**SECTION 4.55(1A) MODIFICATION APPLICATION – SSD 6966
BUILDING R5, ONE SYDNEY HARBOUR, BARANGAROO SOUTH**

This modification application has been prepared by Ethos Urban on behalf of Lendlease (Millers Point) Pty Ltd (Lendlease), pursuant to section 4.55(1A) of the *Environmental Planning and Assessment Act 1979* (EP&A Act) to modify Development Consent SSD 6966 relating to Residential Building R5 at Barangaroo South (the site).

Figure 1 Approved Level 15-16

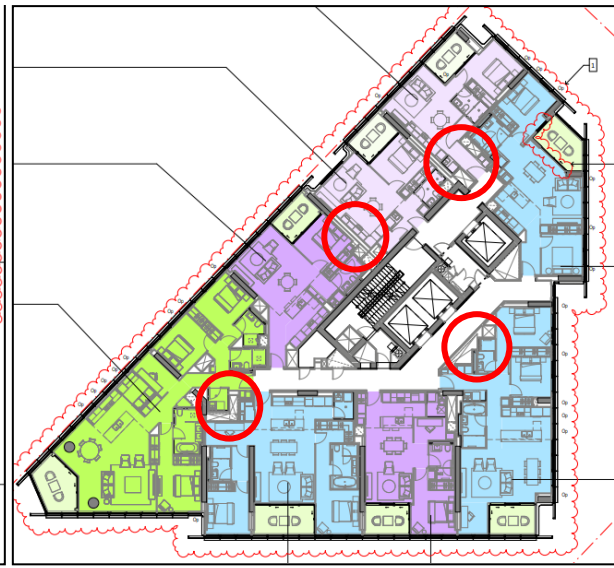
As a result of ongoing internal design changes throughout the building (as discussed below), the internal layout of apartments across the building, including apartments from level P1 through to level 27, have been amended. Design refinements has necessitated changes to the internal structure and risers of the building, requiring subsequent amendments to the internal apartment layouts. These layout changes are largely immaterial and do not result in any significant alterations to the overall useability or amenity of the apartments. This is discussed further at **Section 4.3**.

Figure 1 and **Figure 2** below are an example of the proposed changes from the approved plan, with example structure and riser changes circled in red.

Figure 4 Proposed Level 26 FFL

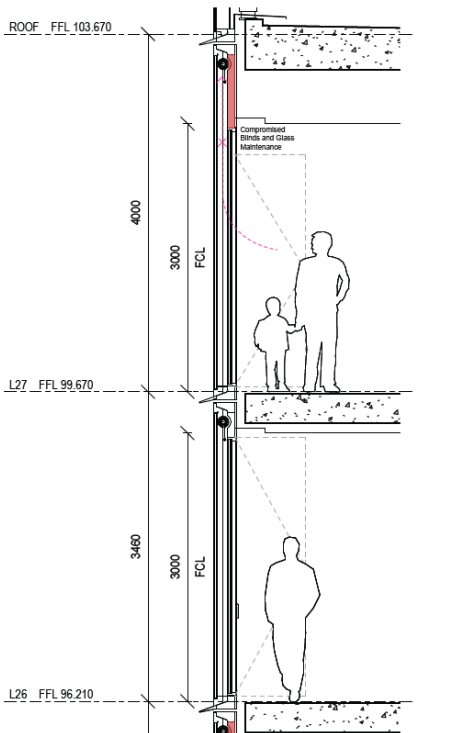
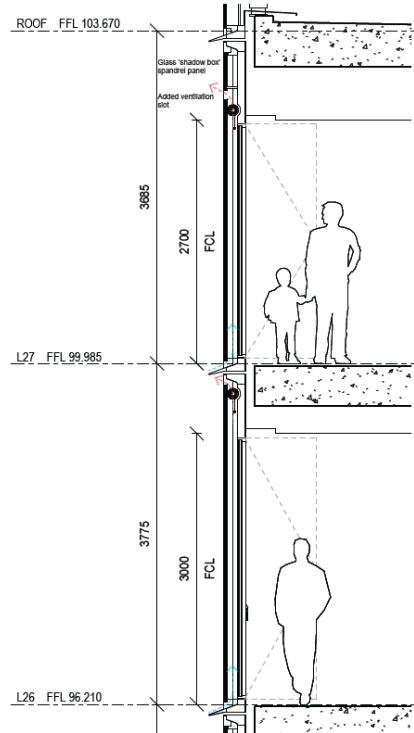
As a result of structural constraints, the desired 3m floor to ceiling height at the Level 26 ‘Skyhomes’ has not been achieved. As such, a design solution is proposed to raise the floor slab of Level 27 by 315mm, which will enable 3m floor to ceiling heights on Level 26. This will result in a subsequent reduction of the floor to ceiling height of Level 27 to 2.7 metres. As a result of these amendments to the finished floor levels, the layout of the internal OCF façade has been revised. The proposed alterations are shown below in **Figure 3** and **Figure 4**.

Figure 6 Excerpt of proposed North West elevation

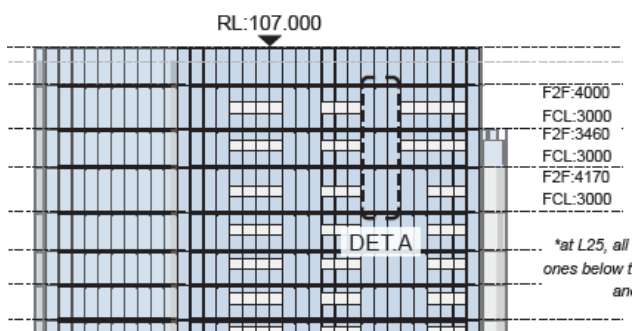
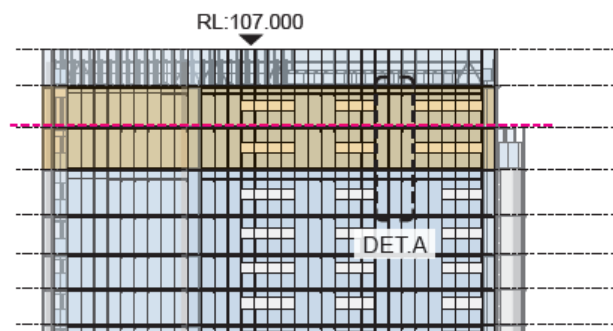
As a result of the finished floor level revisions for level 26-27, there will be minor consequential amendments to the panel fringe heights on the external façade, as is shown below in **Figure 5** and **Figure 6**.

Figure 8 Proposed east elevation identifying ventilation slots – Level 1

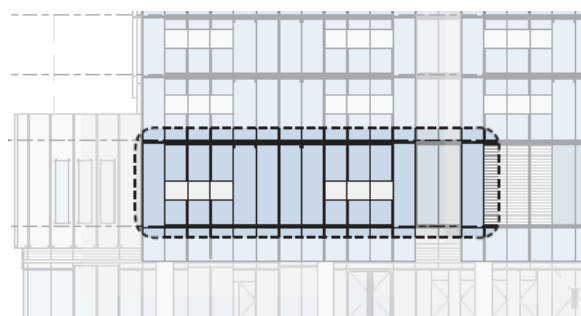
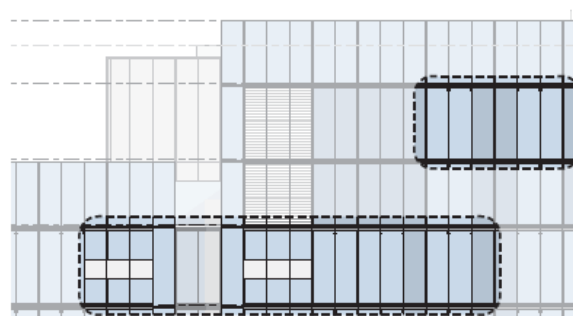
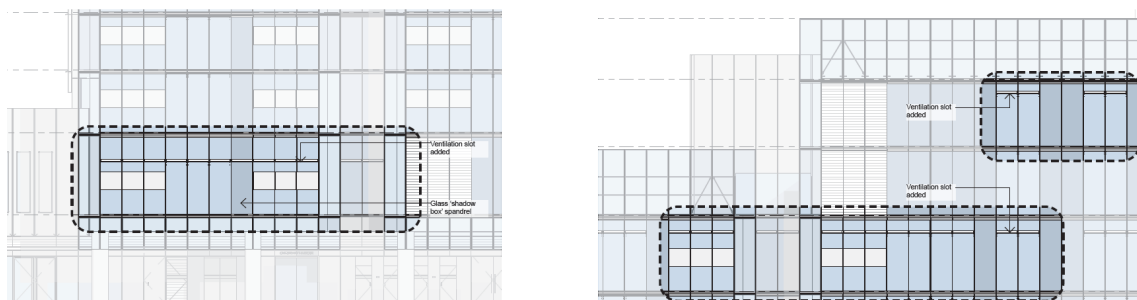
In addition to this, it is proposed to include additional ventilation slots within certain panels external to these floors, as well as on Level 1. It is noted that these slots will be consistent in design with existing ventilation slots currently incorporated into the approved façade design. The location of these additional ventilation slots can be seen below in **Figure 7** and **Figure 8**.

Figure 10 Proposed sliding doors layout

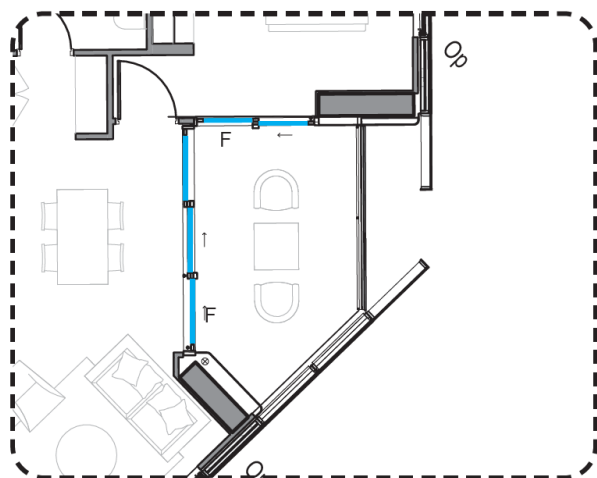
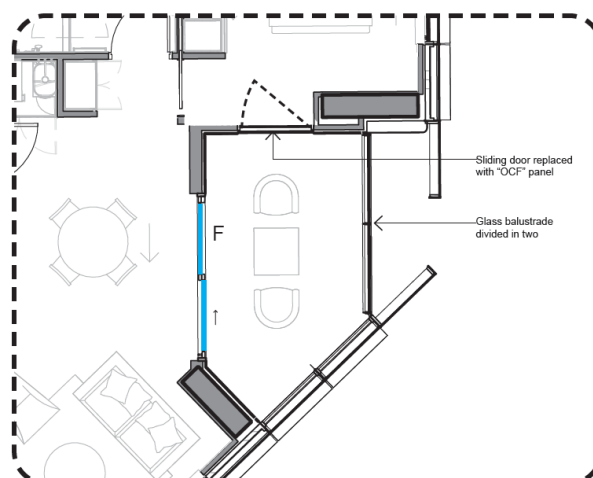
In order to improve access from Apartment 05 on each level to the adjacent balcony, the existing twin panel sliding door is proposed to be replaced with an open cavity façade panel. The approved sliding door layout resulted in a constrained access door from the bedroom to the balcony, where the width of the sliding door was too narrow for accessibility. The introduction of the open cavity façade panel maintains access to ventilation from the balcony and results in an improved internal apartment layout. Subsequent façade adjustments are also proposed, including the provision of an additional façade panel joint. This is highlighted below in **Figure 9** and **Figure 10**.

Figure 12 Proposed Level 28 Plan

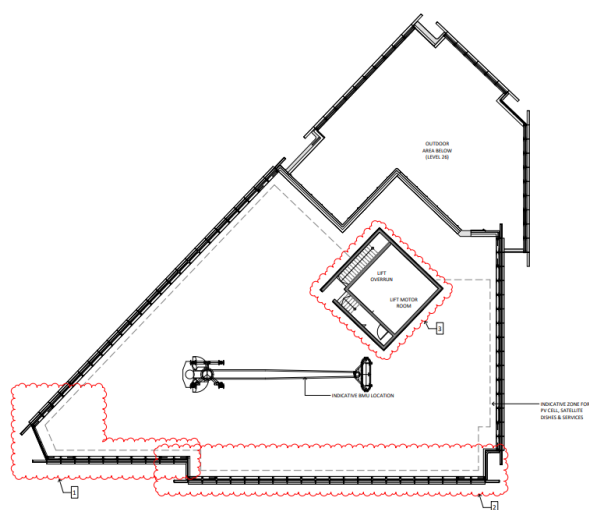
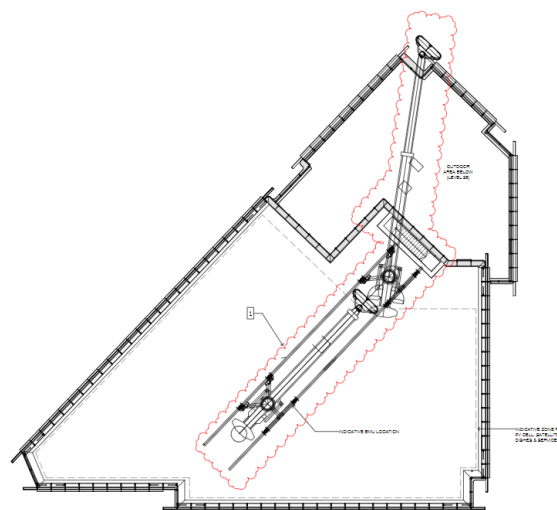
Several refinements to the roof layout of the building are proposed to improve its visual impact from surrounding residential buildings. These refinements include

- Removal of the lift motor room with adoption of a new vertical transportation strategy which removes the need for a lift overrun and improves the visual appearance of the roofscape.
- The removal of the lift motor room allows for a more efficient layout of building maintenance units, improving access to the Hickson Road/Waterman Quay façade area.
- More efficient layout of photovoltaic cells, maximising the available renewable energy opportunity.

Figure 16 Proposed Level 2 façade layout

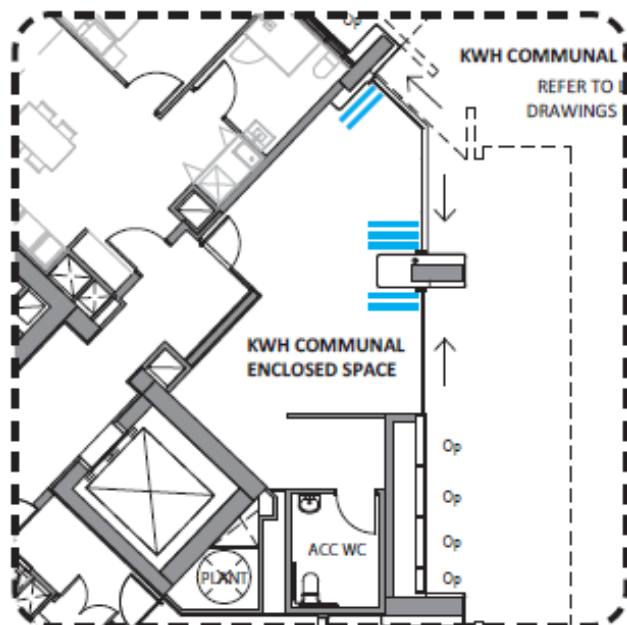
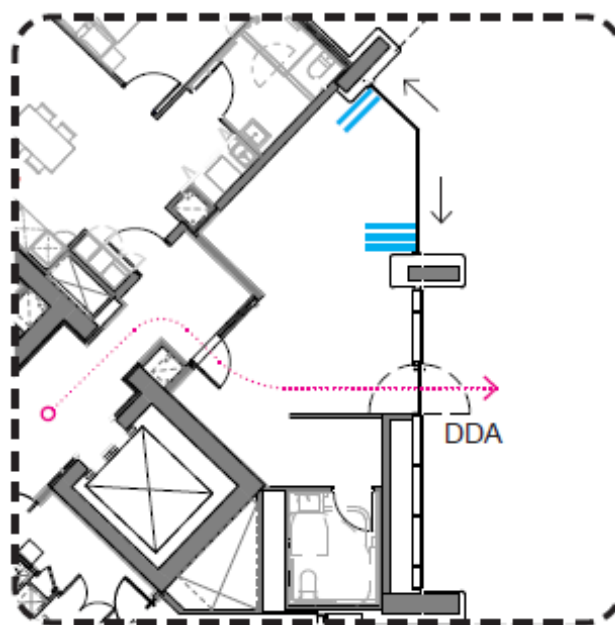
A minor amendment to the Key Worker Housing common space façade on Level 2 of the podium is proposed to provide a DDA compliant pivot door to the external terrace. This is highlighted below in **Figure 19** and **Figure 20**.

Figure 19 Approved signage zone – East façade

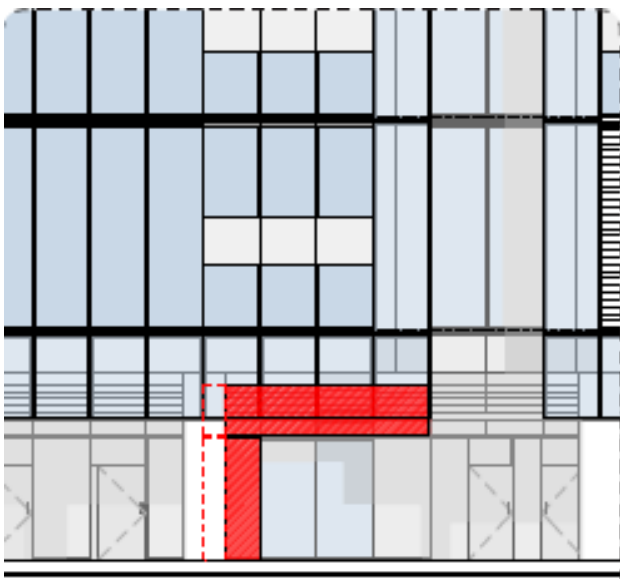
Through further detailed design development of the podium façade, as well no signage now proposed adjacent to the Ground level entrance doorways, it is proposed to revise the location of potential building identification signage zones in the following locations:

- Southwest façade entry vestibule.
- East façade entrance.

Only one zone will be used for signage, and the revisions will expand the possible final location of such.
